Spokes' Response to the Draft Canterbury  
District Local Plan 2040

Published May 2024

## Wingham and Littlebourne to Canterbury

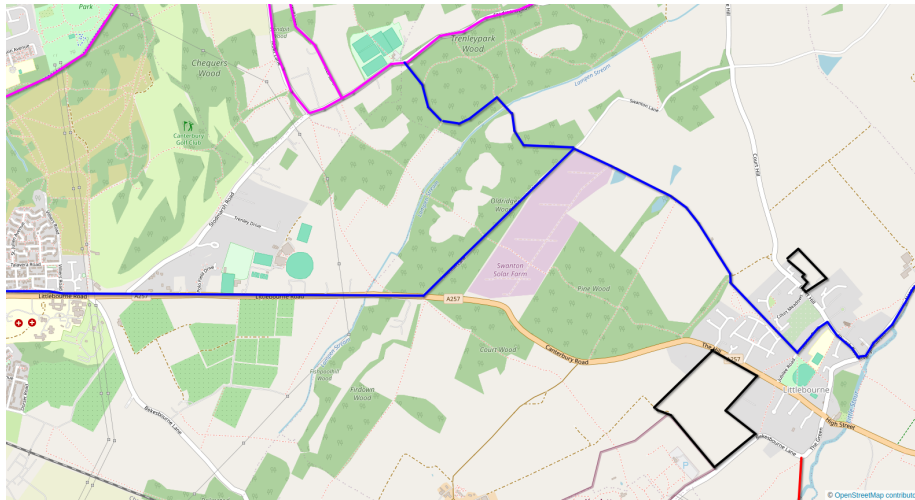
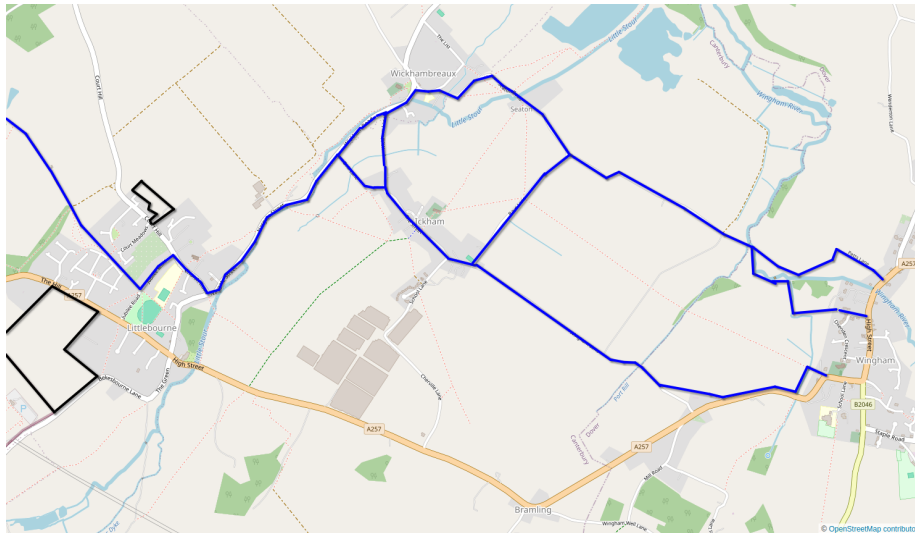
Proposals R10 & R10a, whilst welcome, don't provide a particularly direct link from Littlebourne to Canterbury. There are no proposals to link Wingham, just over the border in Dover District, to the cycle network at all. Both villages have sizable populations. There are two land allocations within the draft Local Plan at Littlebourne which could provide funding towards them; R7 "The Hill, Littlebourne" and R8 "Land north of Court Hill". We therefore put forward these possible options.

Between Littlebourne and Swanton Lane we propose the use of public foot-path CB147. Part of this is a track used for the access to some properties and fishing lakes. Part is already a paved path. A further part would require surfacing. This route includes some gates which would need adjusting to allow cycle access.

At Swanton Lane public footpaths CB147 and CB525 could be followed west of the road through Trenley Park Wood to reach National Cycle Route 1 on Stodmarsh Road. NCR1 can then be followed into Canterbury.

Alternatively, Canterbury could be reached by following Swanton Lane to A257 Littlebourne Road and developing a shared use path beside this road into Canterbury. We would envisage that this would meet and use the new path parallel to the A257 at the former Howe Barracks site, where it can join Canterbury's wider cycle network.

### **C5**

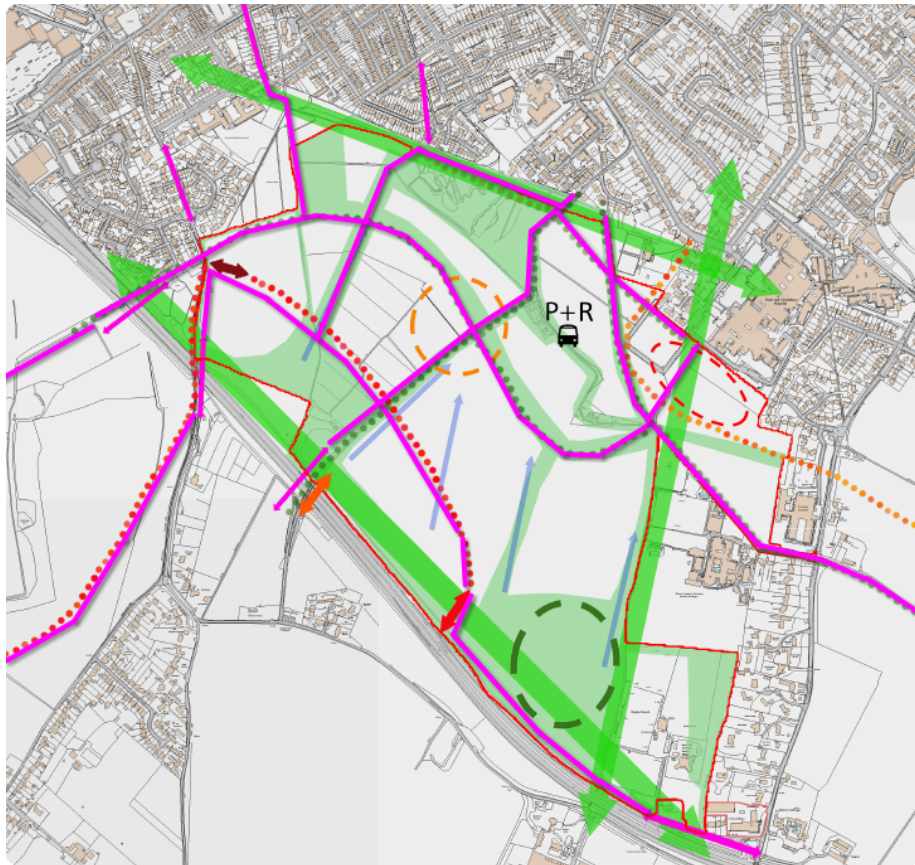
Below we show an annotated copy of the concept masterplan. We have added further pink lines showing how a dedicated traffic-free cycling and walking network could be developed within the allocation here.

- The corridor for the link road must have a wide (at least 4 metres) shared cycle path beside it capable of supporting busy bidirectional cyclist and pedestrian use without conflict.
- Connections should be made to the existing cycle network, and that proposed in the Draft Local Cycling and Walking Infrastructure Plans at:
  - The Birch Road underpass beneath the A2, connecting as directly as possible across the Saxon Fields site, including passing and connecting with the planned school on the site;
  - Connection to the existing cycle path to Simon Langton Boys' School and the Kent & Canterbury Hospital, whilst serving the community hub;
  - A shared cycle connection to Lime Kiln Road, which enables onward cycle journeys into the city or via Hop Garden Way.

**C7**

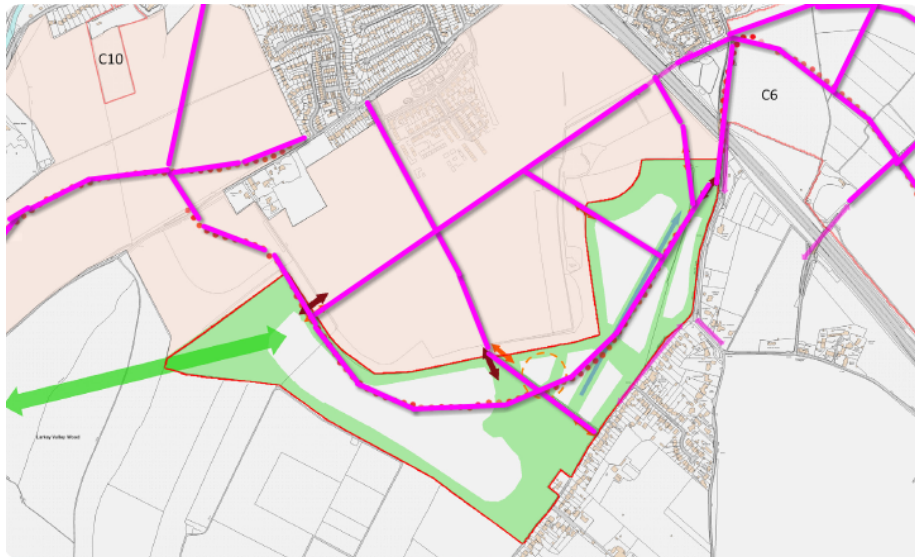
Within this allocation we again believe that the link road must have beside it a wide (4m+) shared cycle path capable of comfortably accommodating high cyclist and pedestrian flows. Additionally cycling links to the neighbouring consented and proposed development sites should be maximised. We have annotated the concept masterplan with pink lines showing these:

**C9**

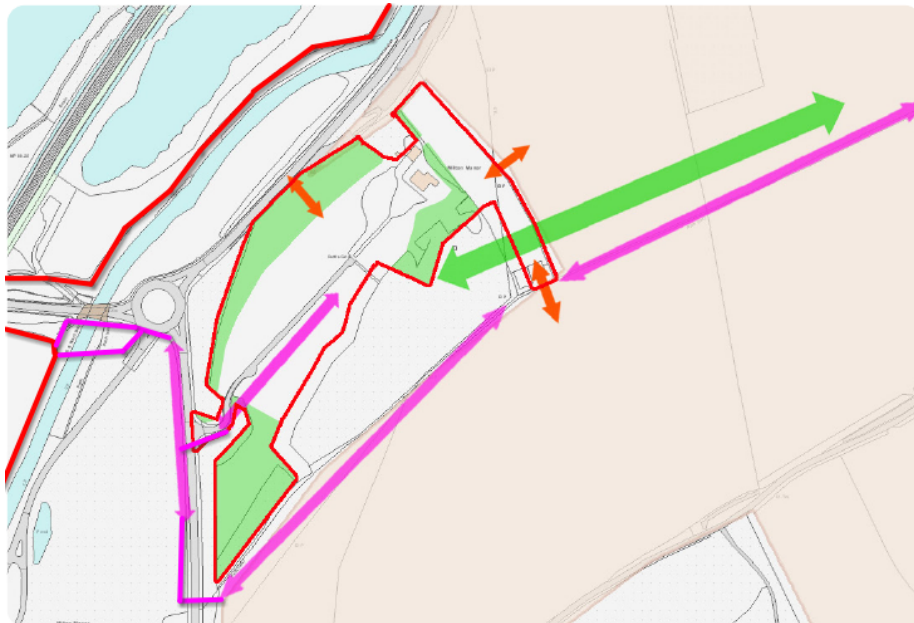
Strongly agree - In the map below the existing Great Stour Way cycle route is annotated in red with potential alignments of a shared cycle path on the west side of Milton Manor Road. Access should incorporate a connection to the existing adjacent site, already under construction, together with a link to the Great Stour Way either at the existing CB463A gate adjacent to the A28, or via provision of a separate cycle / pedestrian bridge over the river from Bretts land, with their consent. This may involve a slight re-routing of public footpath CB541 to take in this new bridge.

### **R5**

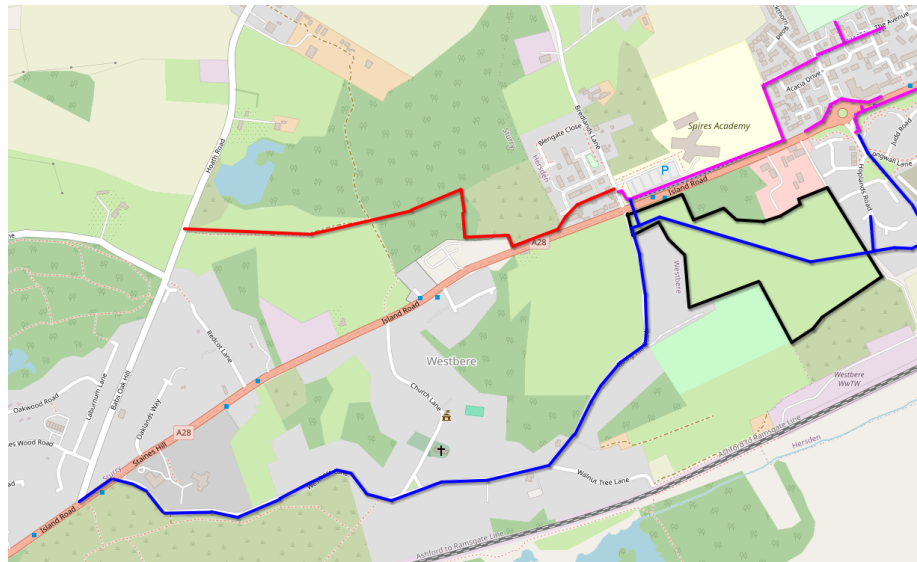
The proposed plan has a duplicate part (ii). We are commenting with respect to the first of these, concerning the cycling connections to Sturry, in addition to point (i) concerning the cycling connections to Hersden and the adjacent Hoplands development. We agree that both sets of cycle connections need to be made. The connections to Hersden and Sturry aren't shown clearly on the proposal's concert masterplan.

We believe that a cycle connection for the full length of the site would be most beneficial both for this site and for the adjacent Hoplands site. A toucan crossing and shared cycle path must be provided over the A28 to the Spires Academy shared cycle path. This will also provide a connection to proposal R9 in the LCWIP, providing an onward cycle connection to Sturry.

provide the funding to achieve a crossing between Westbere Lane without cyclists needing to cycle on the A28 road itself. A controlled crossing would be needed due to the traffic volumes and speed.

## R6

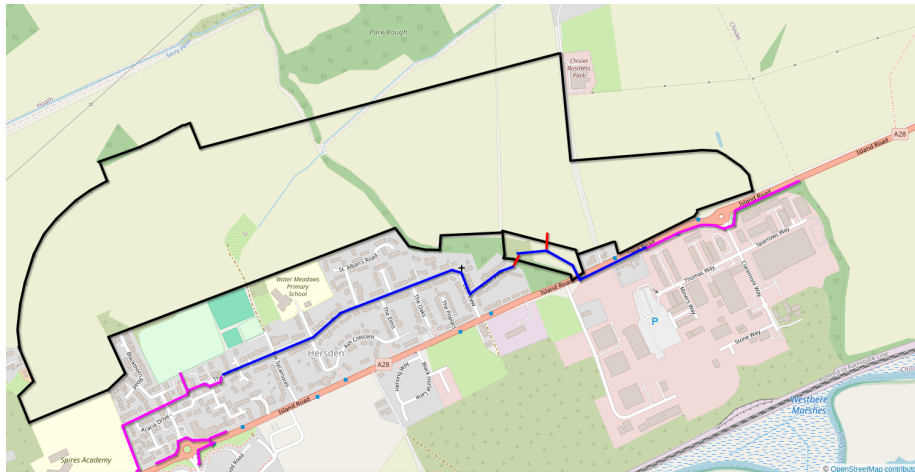
Agree. This site must connect with the adjacent carried-forward site “Land North of Hersden”, as indicated. It must also connect with the shared cycle path beside the A28 to the industrial park almost opposite, since this will provide a viable route to reach the employment locations here by non-motorised means. As indicated on the concept masterplan for the site a cycle connection must be formed to the adjacent North View. This will provide the opportunity for onward cycle journeys through the existing development at Hersden, such as to Spires Academy. The cycle connection to the adjacent carried-forward site will provide alternative, but less direct, cycle routes through too. For example, we could envisage cycle connections to The Sycamores and Blackthorn Road, too. These could be shared use paths, where The Avenue leaves less space for this.

## **R7**

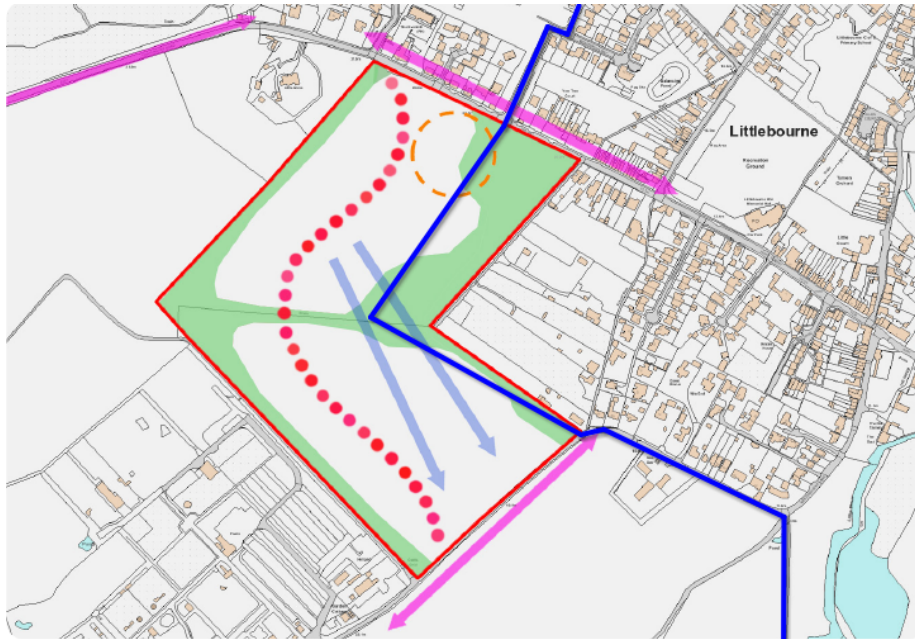
Agree, however cycle access across the site should be indicated. This could be adjacent to or follow a more direct route than the indicated link road. We note that if a cycle connection were developed across to Wenderton Way then a link to public footpath CB147 could be formed via several options, such as Birch Road, Bluebell Avenue, etc. In our response to the proposed LCWIP, we note that following CB147 would provide a good first link for a cycle route between Littlebourne and Canterbury. Funding from development at this site must be sought for the development of the proposed R10 / R10a routes in the LCWIP and our proposed route along CB147. Those should also be shown on the plan as opportunities to improve cycling / walking access and safety and included in the accompanying paragraphs.
